**Addendum No. 2**  
**Page 1 of 2**

**TO:** Prospective Bidders  
**SUBJECT:** Addendum No. 2  
**PROJECT NAME:** City Center Site Work  
**JJC PROJECT NO.:** B20045

24"X24" FRP STRAIGHT  
WALL STACKABLE  
HANDHOLE DETAIL

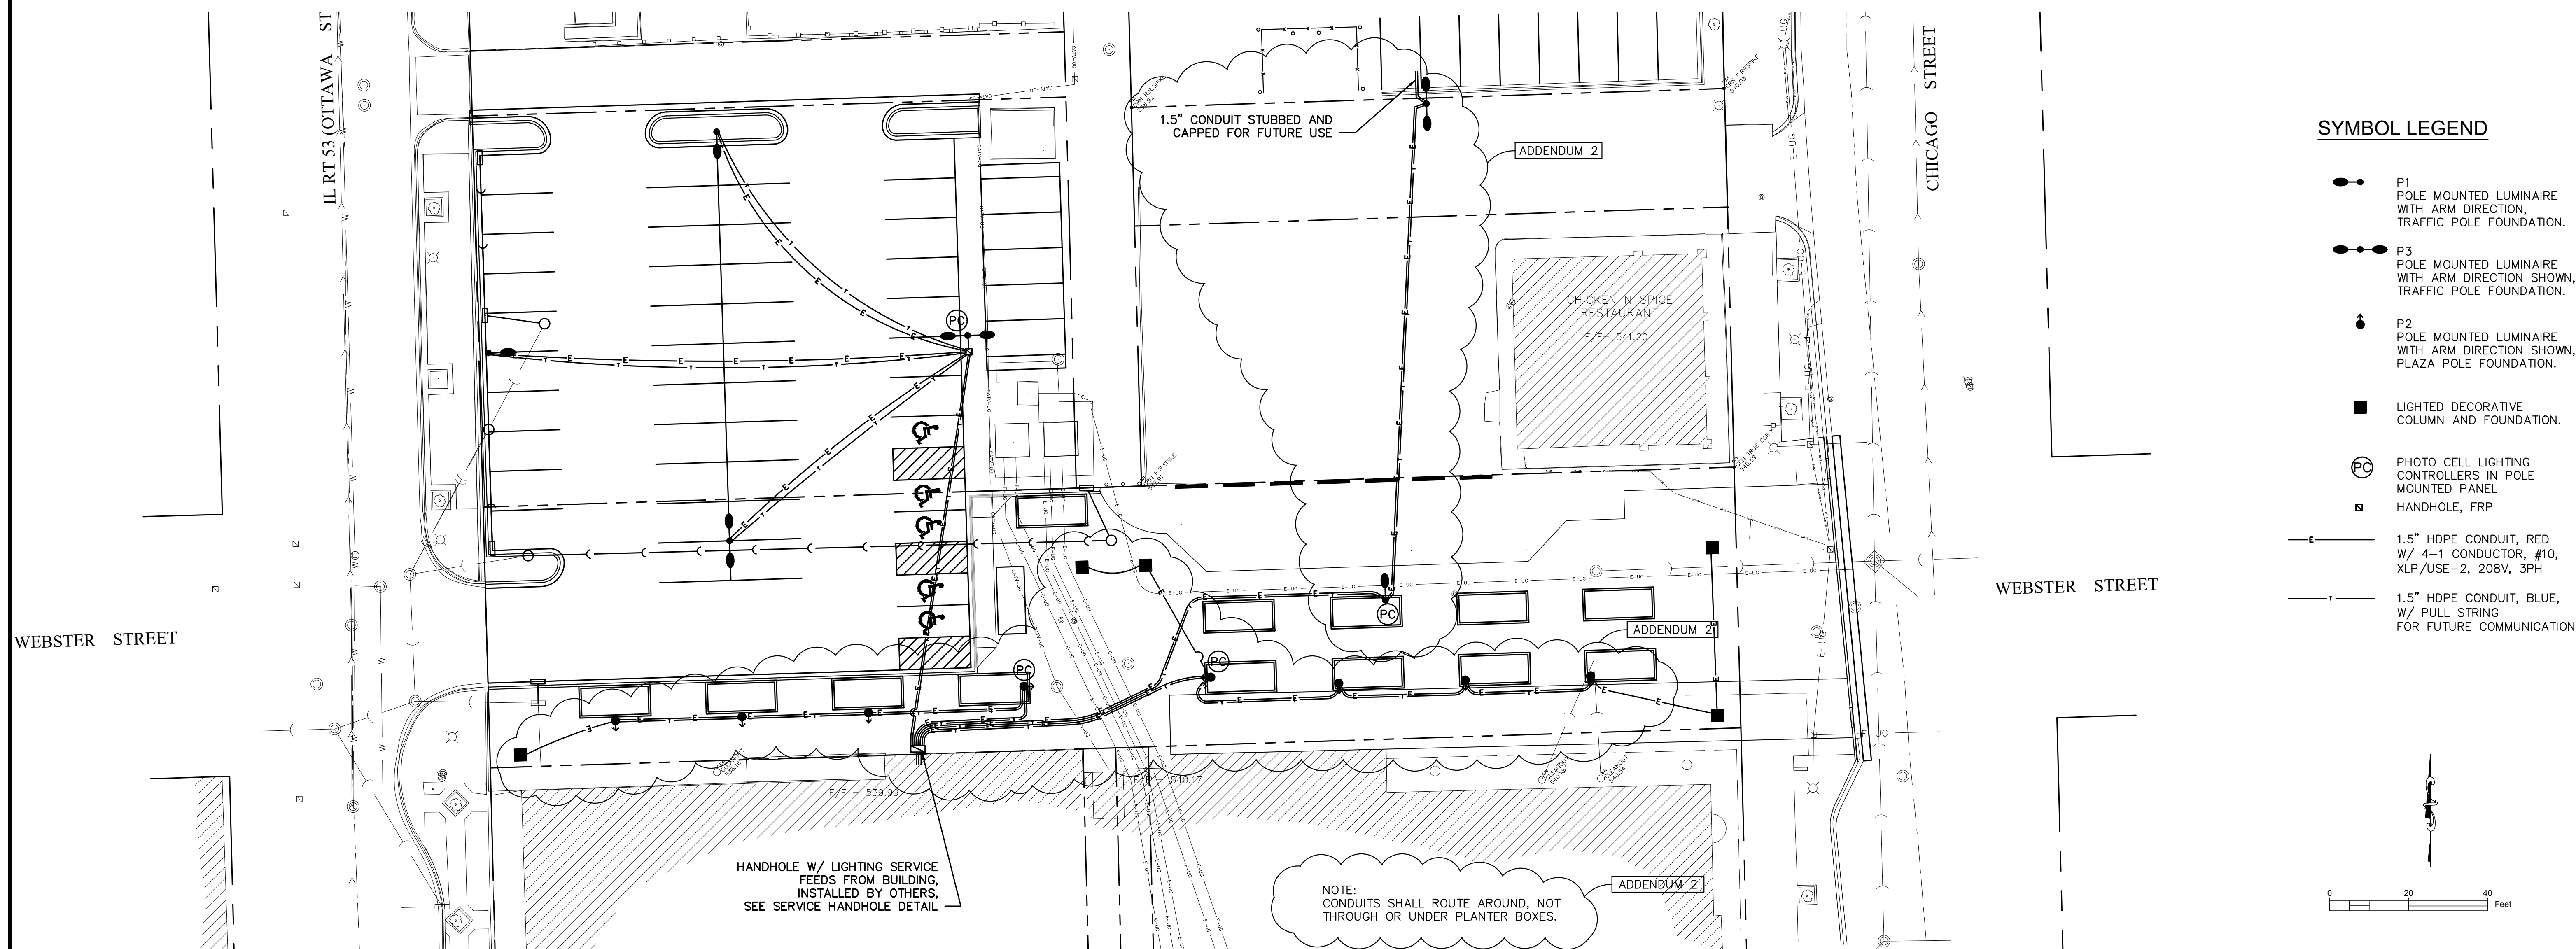
9. Sheet 12/18 The restrictor manhole has been modified per IDOT request
10. Sheets 13-14/18 No further revisions
11. Sheet 15/18 Additional parking lot lights, including conduit revisions

- i. The electrical service handhole has had details added
12. Sheets 16-18/18 No further revisions
13. Sheets L1-L3/L3 No further revisions
